# Intel<sup>®</sup> LXT9880A/9860A and LXT9883A/9863A Multi-Port 10/100 Mbps Repeaters

Specification Update

*January 2004*

Figure 1. Order Information – Sample

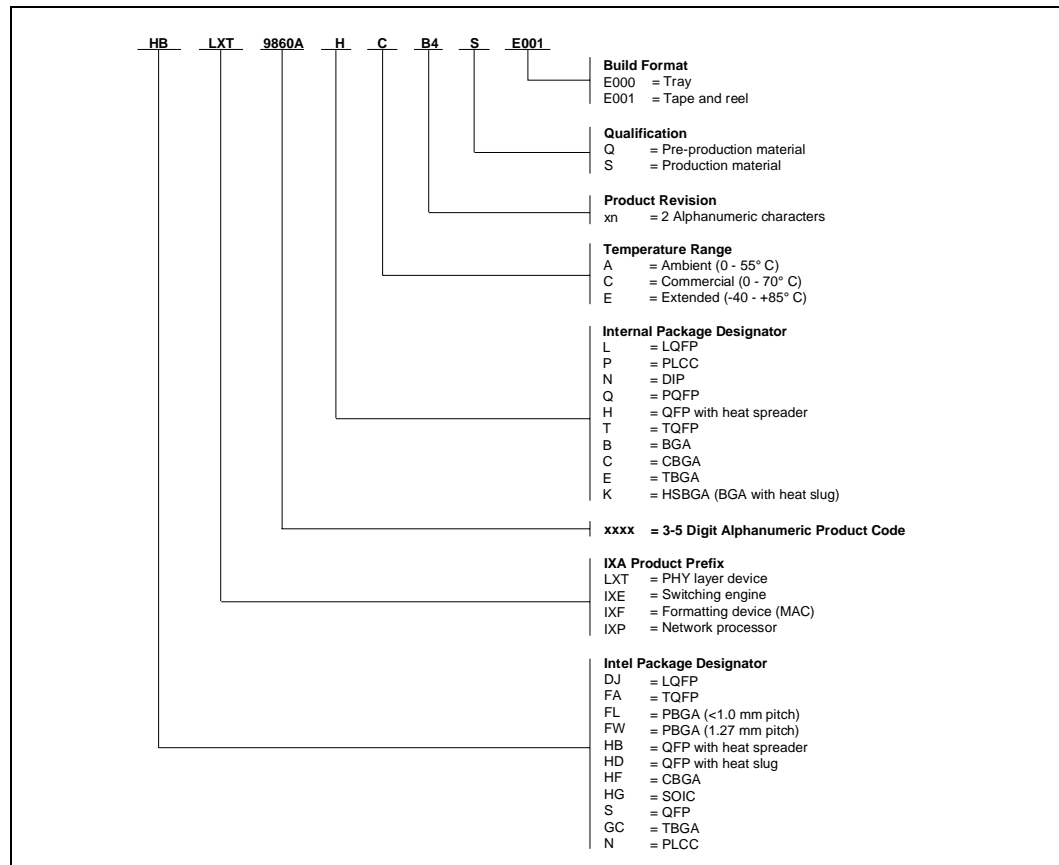
Table 1 and Figure 1 will be added to the next revision of the LXT9880A/9860A and LXT9883A/LXT9863A Datasheets.
